Access Compliance Report

Public Rights-of-Way

(Curb Ramps)

Intersection ID: 4964	Main Street: BREEZY_MORN_LN	Cross Street: HEDGECREST_PL	Location: E
ADA ID: 5044D2AAC2C0	Ramp Type: Perp	Initial Pass/Fail: Fail	Overall Compliance: No
			Severity Score: 26.25

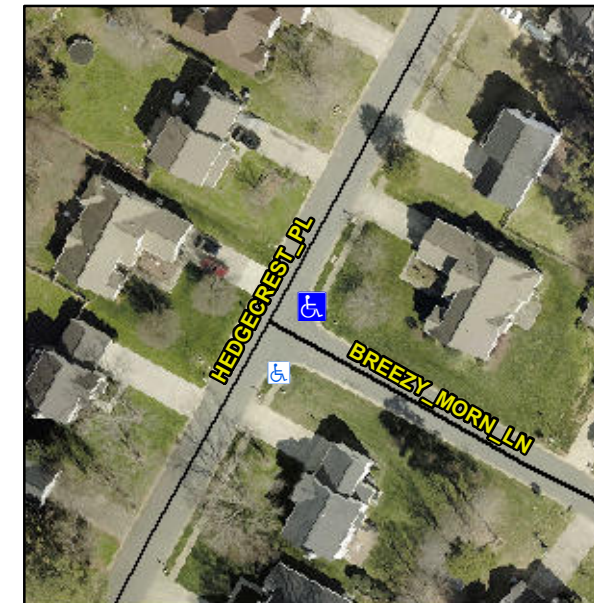
Not Found, R304.2.2, R304.5.3

Compliance	Description	Data	Compliance	Description	Data
N/A	Ramp Length (in)	48.0	No	Ramp Slope (%)	14.8
Yes	Ramp Width (in)	48.0	No	Ramp XSlope (%)	2.8
N/A	Flare Type LT	N/A	N/A	Flare Type RT	N/A
N/A	Flare Slope LT (%)	N/A	N/A	Flare Slope RT (%)	N/A
N/A	Flare Traversable LT?	N/A	N/A	Flare Traversable RT?	N/A
N/A	Landing Length (in)	N/A	N/A	DWS Provided?	N/A
N/A	Landing Width (in)	N/A	N/A	DWS Contrast?	N/A
N/A	Landing Slope (%)	N/A	N/A	DWS Length (in)	N/A
N/A	Landing X Slope (%)	N/A	N/A	DWS Full Width?	N/A
N/A	Landing Curb? (Y/N)	N/A	N/A	DWS Offset (in)	N/A
N/A	Shared Landing?	N/A			
N/A	Gutter Ponding?	N/A	N/A	Gutter Slope (%)	N/A
N/A	Gutter Lip Ht (in)	N/A	N/A	Gutter X Slope (%)	N/A
N/A	Painted X Walk1?	No	N/A	Painted X Walk2?	N/A
	X Walk 1 Direction	To SW		X Walk 2 Direction	N/A
N/A	X Walk 1 Width (in)	N/A	N/A	X Walk 2 Width (in)	N/A
	X Walk 1 Slope (%)	1.4		X Walk 2 Slope (%)	N/A
	X Walk 1 X Slope (%)	2.8		X Walk 2 X Slope (%)	N/A

Remove & Replace Entire Ramp.
